Model: MET-C2ab	Date: 13-May-16	No.: RD239006
------------------------	-----------------	---------------

Subject: Firmware Release Note: PowerSaving Sys		Prepared by: M. Kumagai	
From: 1st Tech Service Sect., MFP/Printer Tech Service Dept.			
Classification:	<input type="checkbox"/> Troubleshooting <input type="checkbox"/> Mechanical <input type="checkbox"/> Paper path <input type="checkbox"/> Product Safety	<input type="checkbox"/> Part information <input type="checkbox"/> Electrical <input type="checkbox"/> Transmit/receive <input checked="" type="checkbox"/> Other (Firmware)	<input type="checkbox"/> Action required <input type="checkbox"/> Service manual revision <input type="checkbox"/> Retrofit information <input checked="" type="checkbox"/> Tier 2

This RTB has been issued to announce the firmware release information for the **PowerSaving Sys.**

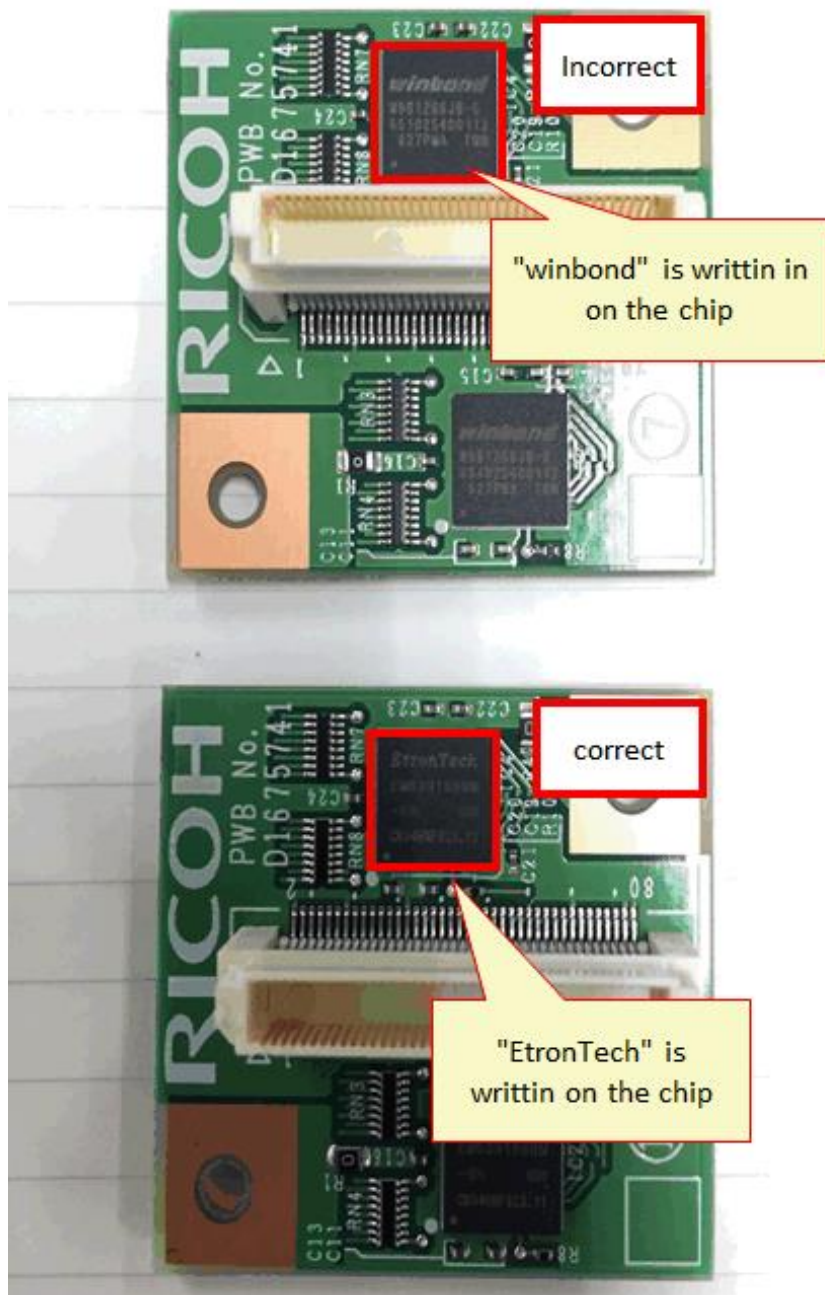
- Changed the value of the resistance on the Fax Memory Unit
- Changed to a different manufacturer of memory modules for the Fax Memory Unit
- The modification has been applied at the factory at Sep 2016.

How to identify if they are affected or not is the text on the chip on the Fax memory board, as shown in the photos below.

Replace the Fax Memory Unit with the modified one.

- Incorrect (affected) is the chip with "winbond" written on it.
- Correct (not affected) is the chip with "EtronTech" written on it.

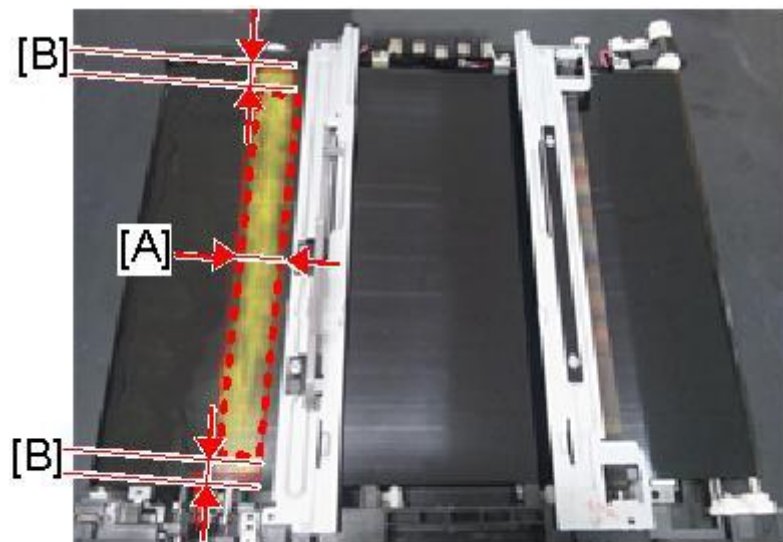
~~7 Attach the image transfer cleaning unit.~~

7 Put toner on the image transfer belt.

Overview

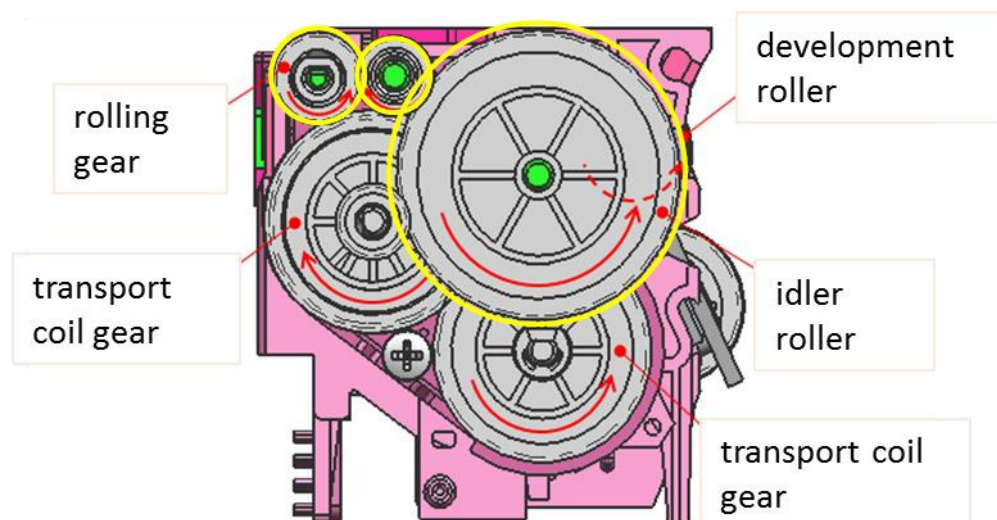
Three new gears (yellow circles) are added. They are driven from the developer collection coil gear, so the seal is automatically wound. This mechanism works at installation and/or replacement.

Figure.1

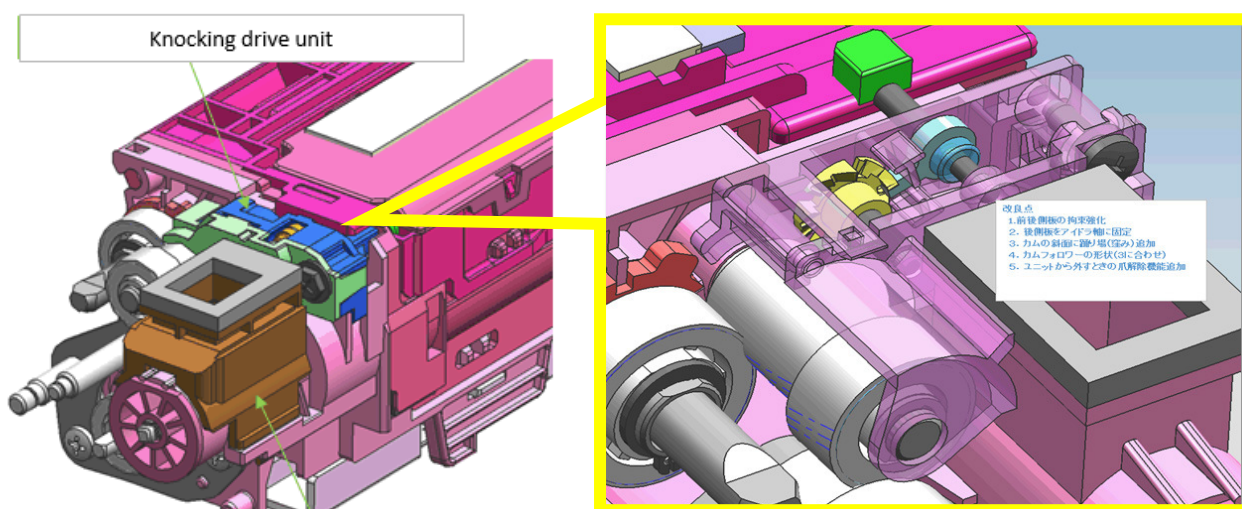
A new knocking mechanism has been added (Fig.1). Normally, the air flows from the development roller to the filter in the development unit (Fig. 2). However, when the filter is full of toner, the inner pressure increases and reverse air flow occurs, which causes toner blasting to occur (Fig.3). To prevent this, the knocking mechanism periodically knocks the development unit cover, so toner in the filter drops back into the development unit. This mechanism works by reverse rotation of the development roller.

Parts change information:

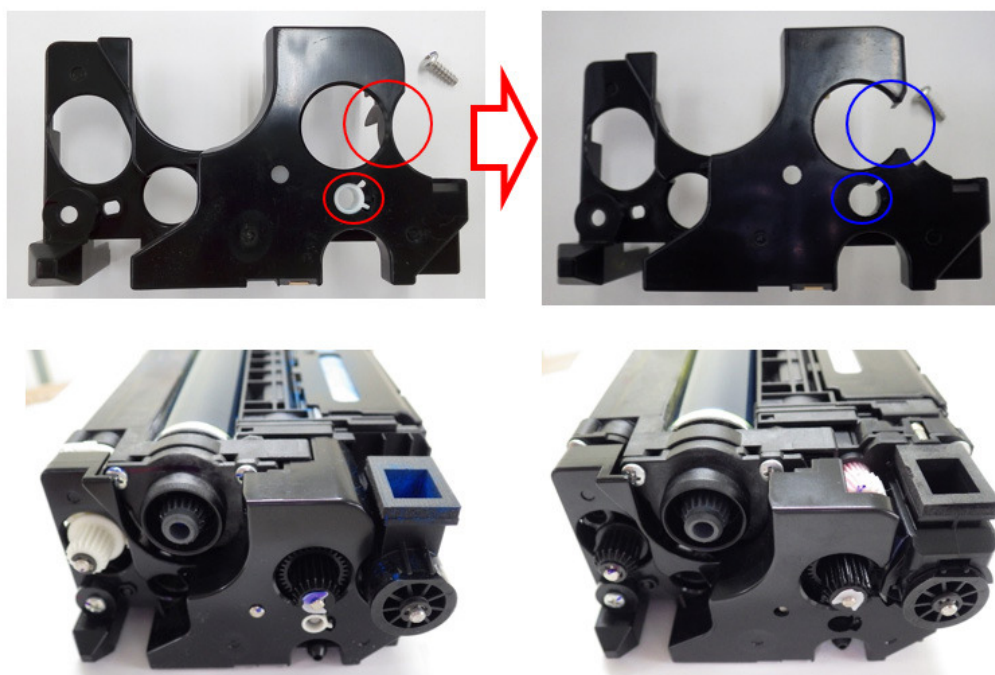
The shape of duct cover on the PCDU was changed. Old duct cover cannot be used with the new development unit.

The duct cover is included to the new development unit and PCDU. Please replace together when you replace development unit or PCDU. Note: It is not necessary to use the white bearing of the old duct cover in the new duct cover.

Model: Met-C2ab	Date: 28 -Nov-17	No.: RD239072a
-----------------	------------------	----------------

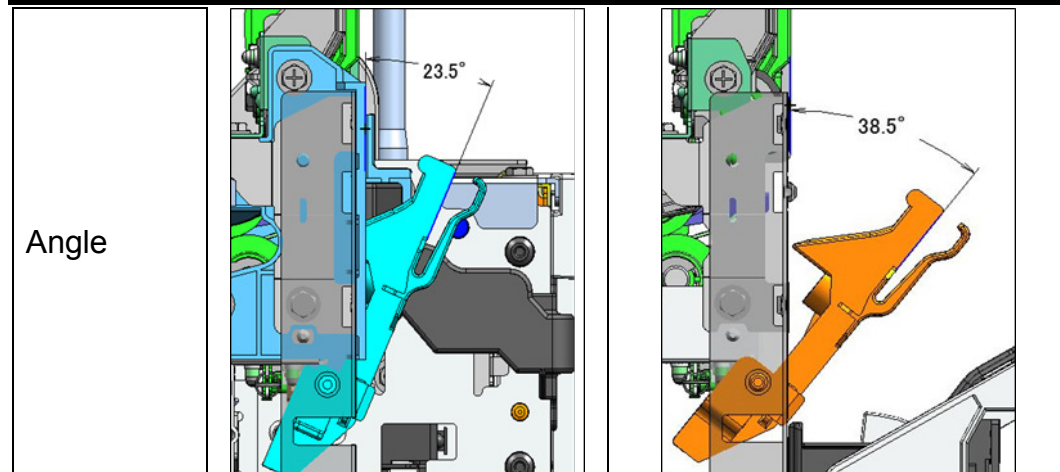
Change: The shape of the guide plate was changed.

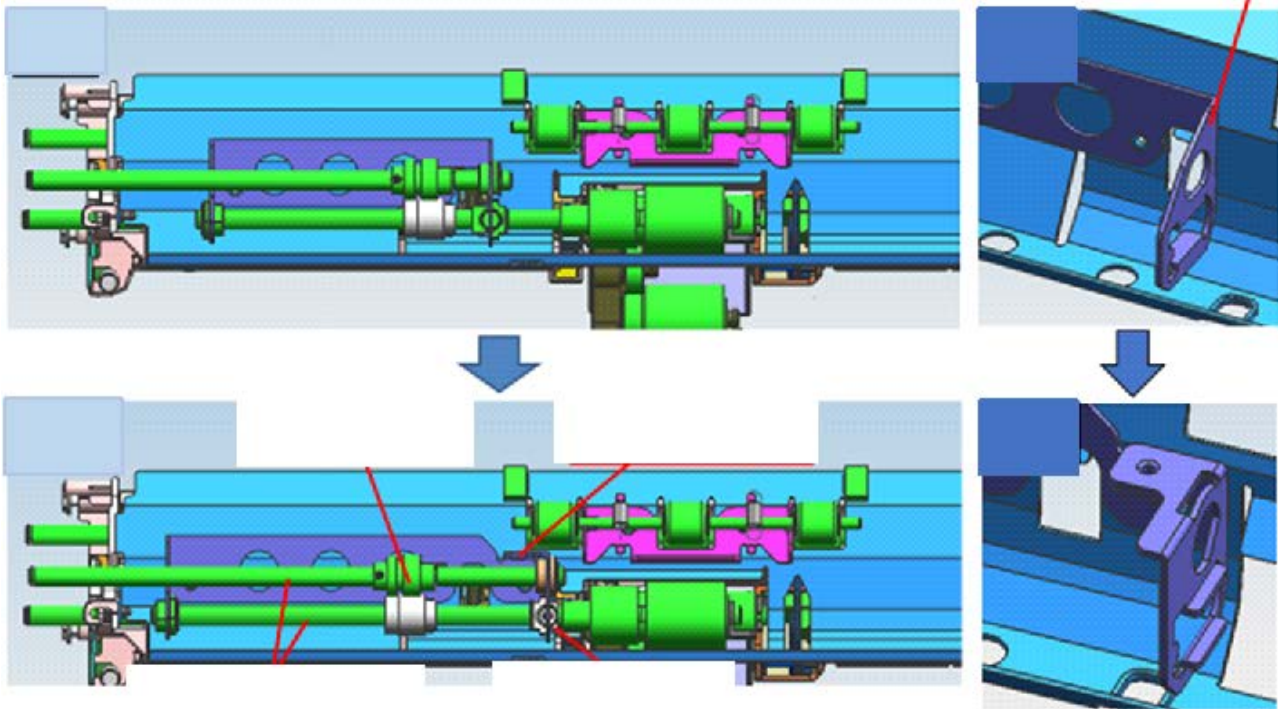
Old P/N <Group B>	New P/N	Description	Int	Q'ty	Note
08050104	08050104	RETAINING RINGS-E:SILENCER:DIA4	-	2->3	C
D1494770	D0BQ2608	SHAFT:SEPARATOR:DRIVEN:ASS'Y	X/X	1	C
M0BW2615	D0BQ2615	GUIDE PLATE:SEPARATOR:ASS'Y	X/X	1	C
D1492619	D0BQ2619	SHAFT:SEPARATOR:DRIVE:ASS'Y	X/X	1	C
D2412653	D0BQ2653	COIL SPRING:PRESSURE:SEPARATOR	X/X	1	C

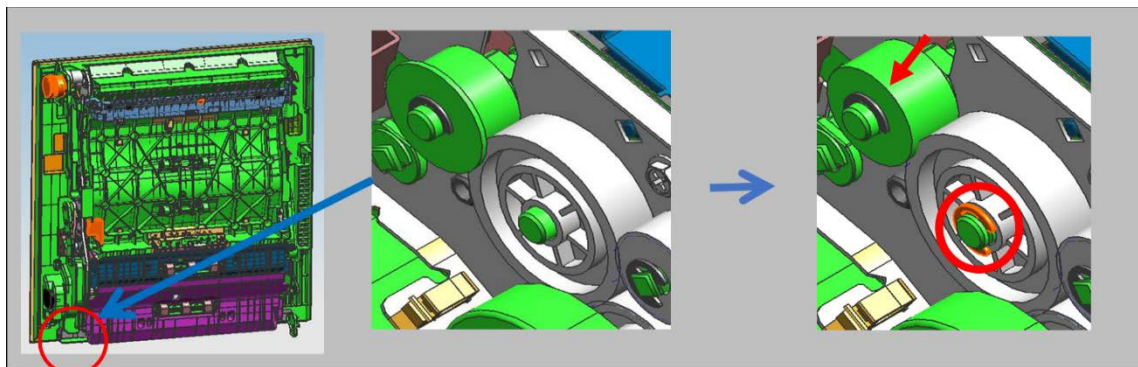
Change 4: There are no protruding parts to hold the gear. An e-ring added to stop the gear in position, and a groove added to the shaft for the e-ring.

Old P/N <Group B>	New P/N	Description	Int	Q'ty	Note
07200040E	07200040E	RETAINING RING - M4	-	3->4	D
D2414631	D0BQ4631	SIDE PLATE:REAR:DUPLEX:PEEN	X/X	1	D
D2414644	D0BQ4644	GEAR:MECHANICAL ROLLER CLUTCH	X/X	1	D
